# SERVICE LETTER 679 - PIPER

**SUBJECT:**  
Fuselage Aft Bulkhead Inspection

**MODELS AFFECTED:**  
PA-30 Twin Comanche  
PA-39 Twin Comanche C/R

**SERIAL NUMBERS AFFECTED**  
30-1 to 30-2000 incl.  
39-1 to 39-155 incl.

TYPICAL VIEW OF AFT FUSELAGE (LOOKING FORWARD)

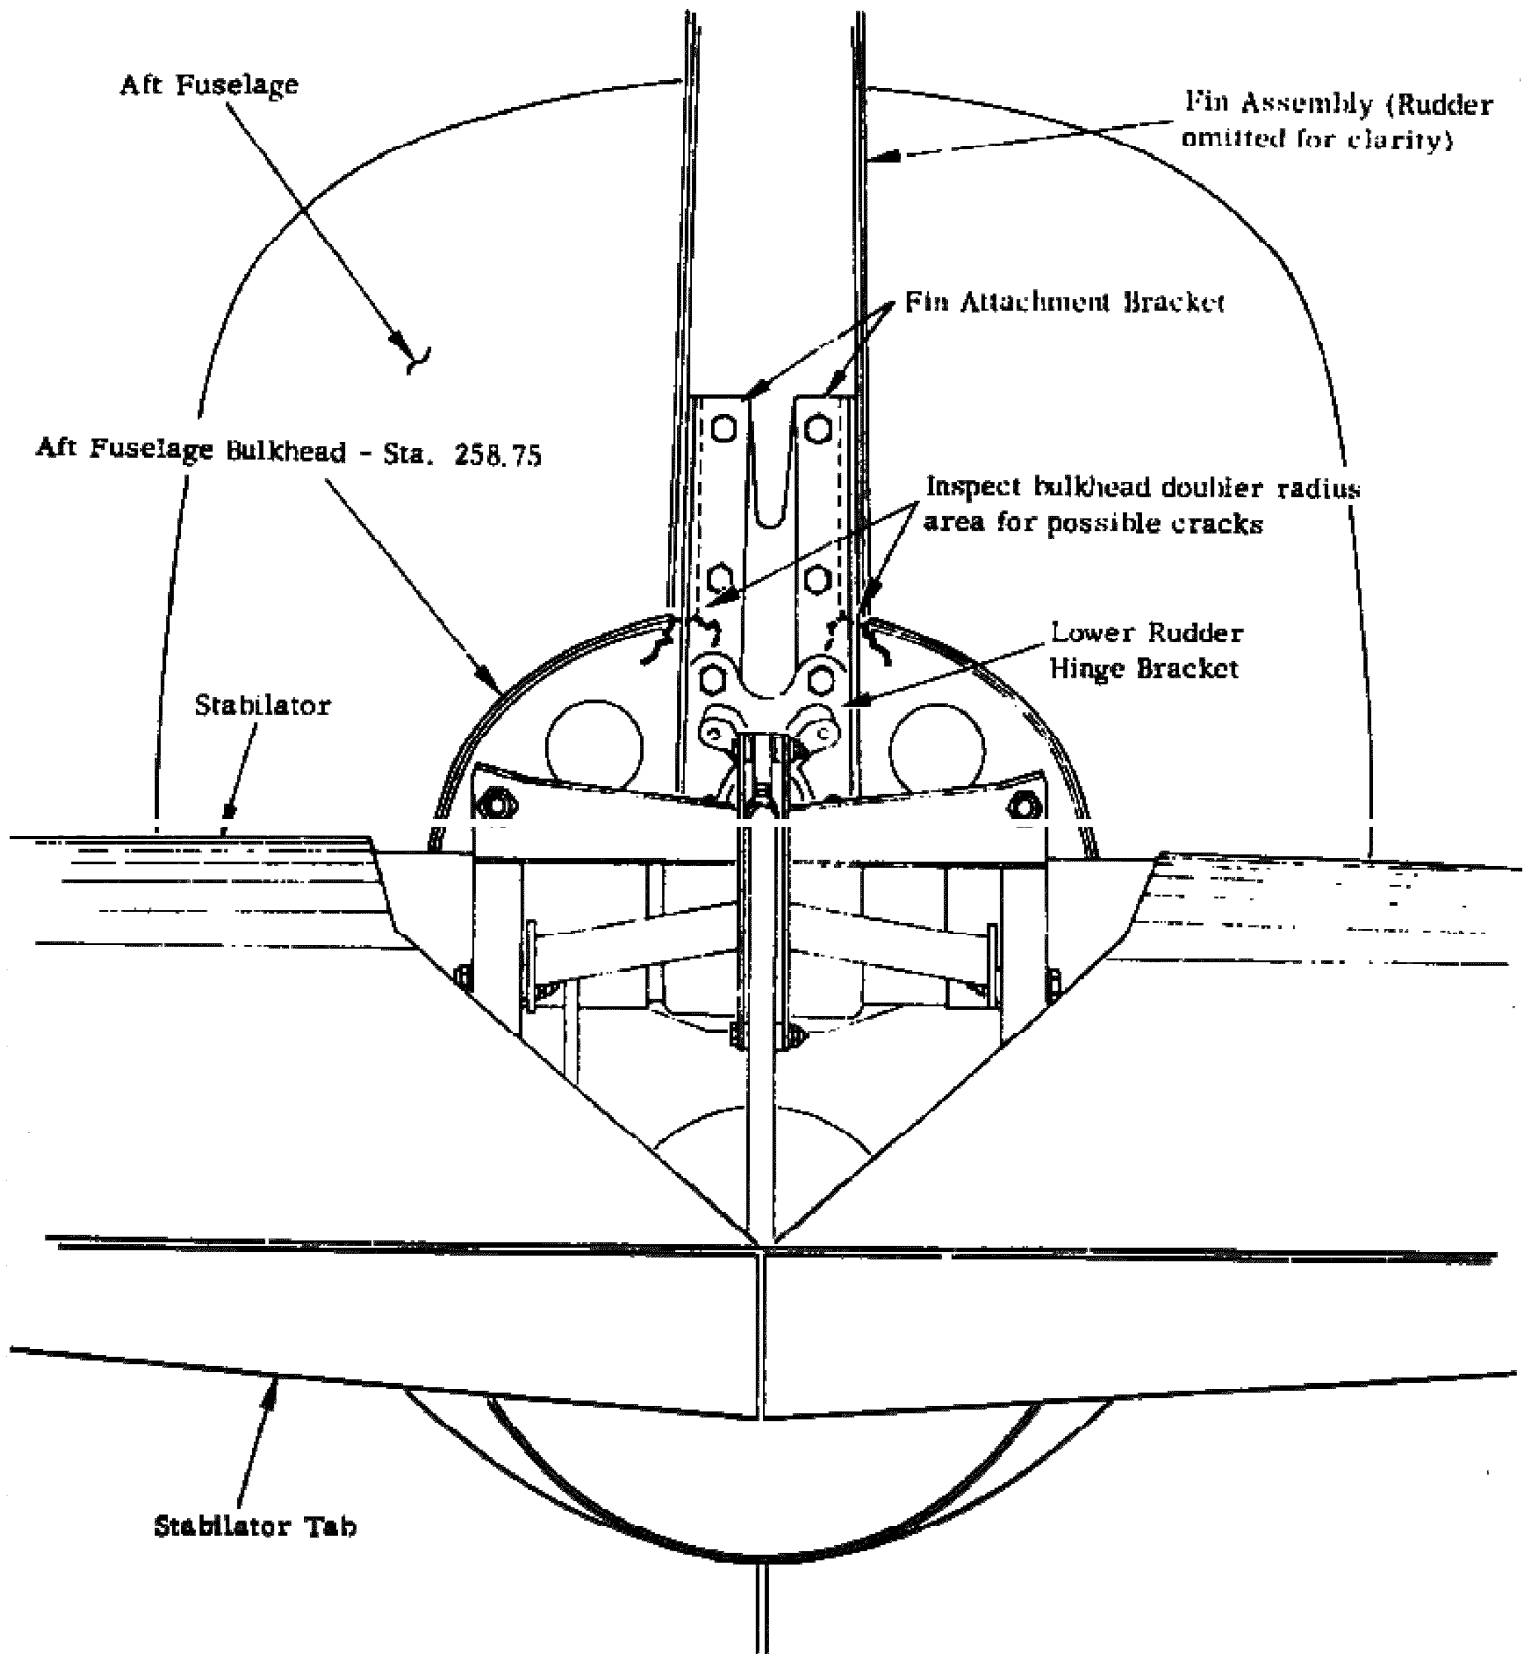
- INSTRUCTIONS:**
1. Remove tail cone fairing assembly from aft fuselage.
  2. Carefully inspect bulkhead doubler on both sides of fin attachment brackets, as shown above, for evidence of cracks.

1. Conduct inspection in accordance with the provisions of the sketch/instruction sheet.
2. If no cracks are detected in this area, no further action is required at this time (except continuing repetitive inspections until Kit 760 783 is installed); however, it is the owner's/operator's option whether to install the Fin Attachment Bracket Installation Kit, Piper Part No. 760 783, to relieve the inspection requirements referenced in Compliance Time, above.
3. If cracks are detected in this area, it will be necessary to install the Fin Attachment Bracket Installation Kit, Piper Part No. 760 783; installation instructions are contained in the kit.
4. Make appropriate log book entry.
